Title - Sujet : Peyto DUA Parking Lot and Trails – Banff National Park	
Solicitation No. - N° de l'invitation : 5P420-20-0024/A	Date : July 28, 2020
Amendment No. - N° de modification : 002	
Client Reference No. - N° de référence du client :	
GETS Reference No. N° de référence de SEAG : PW-20-00919812

Amendment 002

This amendment is being raised to extend the solicitation closing date, distribute questions and answers, to make changes to the tender package, and to replace Appendix 1 – Combined Price Form.

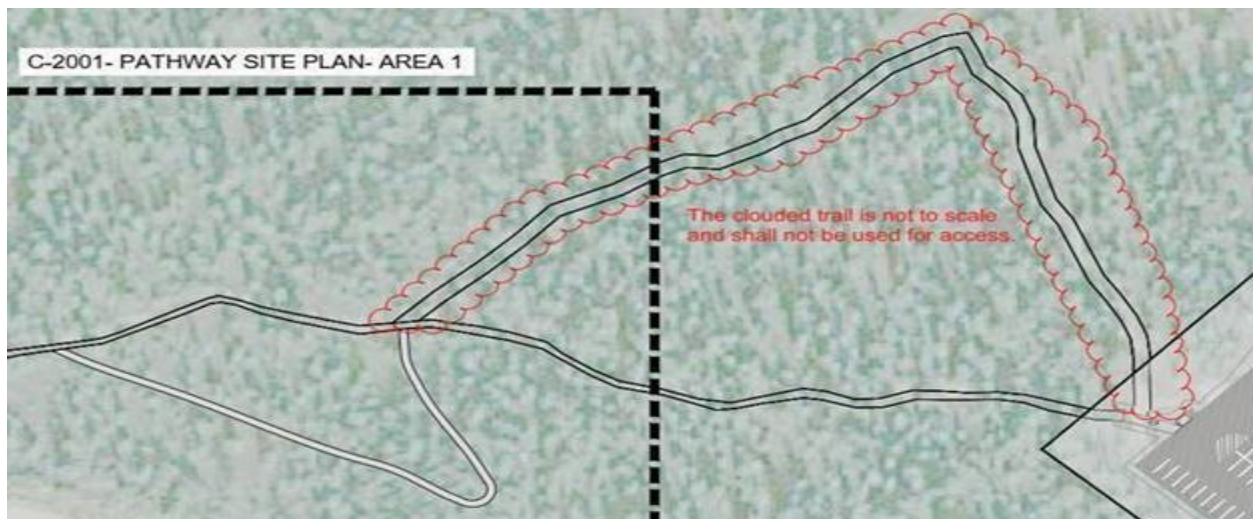
Q4) There are two pathways that originate at the lower parking lot and then intersect where the area 1 trail construction starts. Are both of these available for construction access to the area 1 trail?

Q5) Are there any equipment restrictions (weight or dimension) for the construction equipment that would go from the lower parking lot to the area 1 trail? Examples of equipment would include skidsters, excavators, dump trucks, compaction equipment, and paving equipment.

A4) Please see below snapshot of drawing C-2000 for clarification. The contractor shall use the other existing trails as shown on C-2000 for access. Also note the lower parking lot shown as “NOT IN CONTRACT – WORK BY OTHERS” on C-2000 has been recently paved. The contractor shall be responsible to repair all damage caused to existing trails, parking lots and all other areas.

A5) The trail highlighted below ranges in width from approximately 1.25m and 2m. Weight restrictions are unavailable. The contractor shall assess and determine what equipment to use based on site conditions. As per the specifications, the contractor shall be responsible to repair all damage caused to existing trails, parking lots and all other areas.
